SUBJECT: Forwards addl info re design of piping supports at facility,  
 in response to preliminary findings of NRC pipe support  
 design audit on B50604 & 05 & as followup to SER  
 Confirmatory Item 5.

SHEARON HARRIS NUCLEAR POWER PLANT  
UNIT NO. 1 - DOCKET NO. 50-400  
PIPE SUPPORT DESIGN AUDIT

SHEARON HARRIS NUCLEAR POWER PLANT  
SER CONFIRMATORY ITEM NO. 5  
NRC DESIGN AUDIT ITEM 1

FIGURE III. A. 4-1

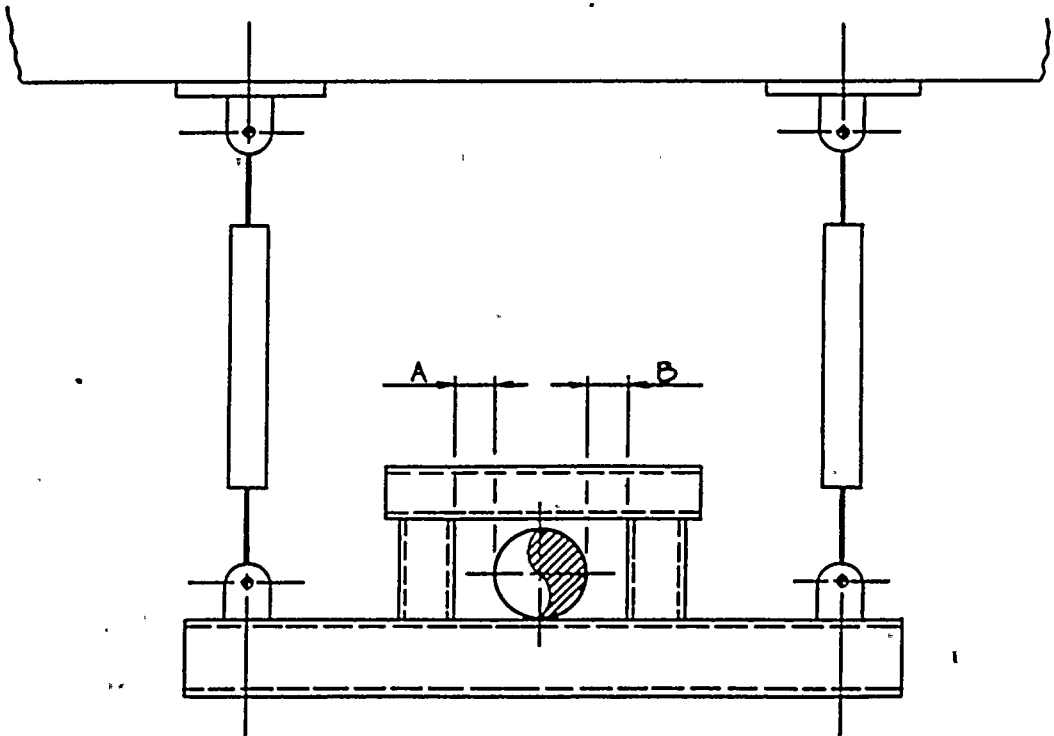
The applicant will identify any other potentially unstable pipe support designs (similar to support CC-H-323) and discuss with the staff the proposed resolution.

3. Based on item from NRR review on June 4 and 5, 1985, Hanger Unit engineers shall review all "double strut/snubber" hangers to ensure the configuration is stable. If the hanger configuration is unstable, the design will be revised to eliminate the instability in the configuration. A "double strut/snubber" hanger is considered unstable if the pipe attachment portion of the hanger can move freely relative to the pipe either axially or laterally. This movement is a result of excessive gaps between the pipe and the pipe attachment. Figure III.A.4-1 (following this paragraph) illustrates a typical "double

CP&L has reviewed approximately 4000 supports/restraints to identify any potentially unstable designs (similar to support CC-H-323). Of the designs reviewed, no configurations similar to CC-H-323 have been identified. Hanger CC-H-323 has been revised to eliminate the possibility of the hanger swinging laterally during a seismic event or twisting enough to prevent the struts from carrying an upward load.

strut/snubber" hanger where instability can occur. If the sum of A and B is greater than the calculated cumulative gap size required for the thermal radial expansion of the pipe, then the support is considered unstable. A U-bolt would be preferable as a pipe attachment in this situation, but shimming the hanger pipe attachment to eliminate the excessive gaps is the most expeditious solution for existing hangers.
